Addendum to Design & Access Statement
Conversion & new dwellings, Ivory Hill Farm
Park Lane, Winterbourne, Bristol, South Gloucestershire
BS36 1AS

04 May 2022

This Addendum to the original Design & Access Statement has been prepared to support an application for a Minor Material Amendment for changes to the access and layout of House 8 - the Bank House. This is the detached new dwelling to the north of the farm buildings. The reasons for proposing this change are explained in the document.

Above: Consented site plan

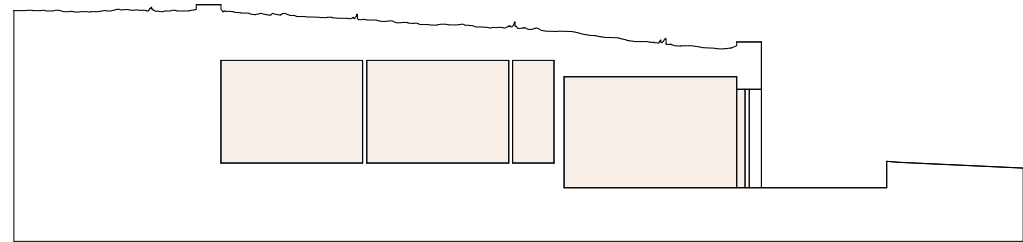
The consented access to the Bank House is via a new drive from the northern edge of the new shared parking area. This drive will need to be cut down into the field as it rises up behind the farmstead. To reach the necessary level with a gradient of 1 in 20, this cutting will be quite significant, and will require a large amount of the field to be removed, adjacent to the historic buildings.

As the project has progressed on site we have become concerned that this work will change the site's character in a negative way. It will be very visible in the public views of the rear of the main range, where we have worked hard to retain the traditional character of the buildings. It will change the relationship that the range has with the field.

The WPD changes have created an alternative access route into the site, which we believe would also provide much improved access to the Bank House, with much less impact on the levels and appearance of the field (and hence the setting of the historic buildings).

The track would need to cut in to the sloping field but the cutting would be much more discreet in this location, as it is some distance from the farm buildings and would be largely out of sight.

Right: Site Plan as proposed highlighting the landscaping features

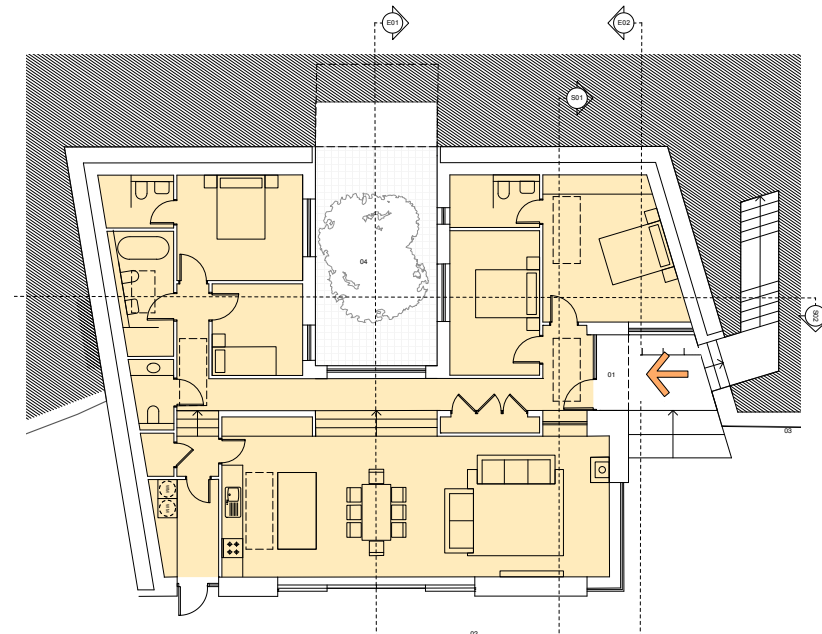
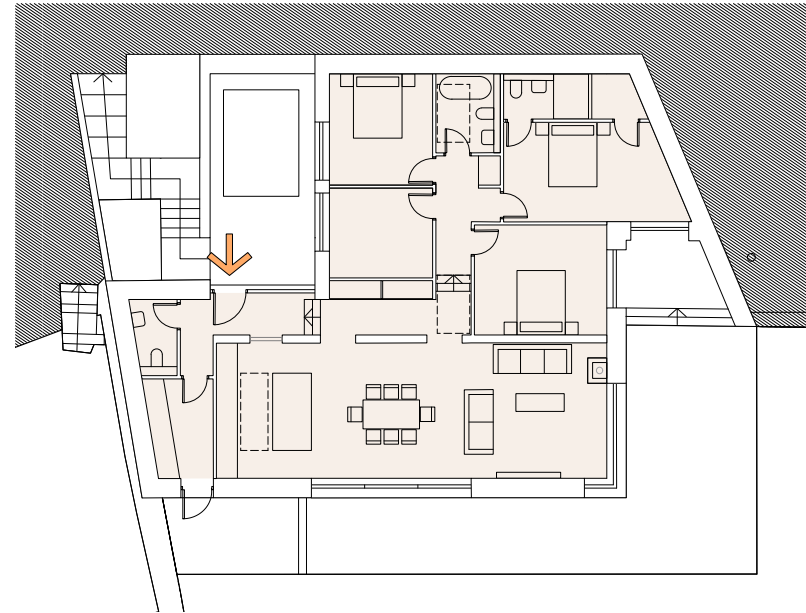
The proposed access would need to be subtly integrated into the existing landscape to minimise its impact. The following features would help achieve this:

- To minimise any impact of an additional entrance, we propose to give the entrance the appearance of field access, with no domestication at all. There would be a simple metal five bar gate on timber posts where the track meets the lane. No trees or vegetation would need to be removed to create this access.

- The shared WPD and Bank House access would be treated as a simple farm track, rather than a domestic driveway. The track itself would be grass, with a grasscrete honeycomb beneath to give the grass protection and prevent the track becoming muddy.

- The grasscrete parking area would be partially excavated to further sit the vehicles down (out of sight), further reducing the impact on the listed buildings. The existing trees and hedgerow would also screen the vehicles from view in this location.

- A new hedgerow (similar to that of the other field boundaries) would be planted along the side of the new track, to screen the occasional vehicle that drives along it. The hedge will also help prevent any domestication bleed into the orchard/wild flower meadow and prevent any unofficial parking.
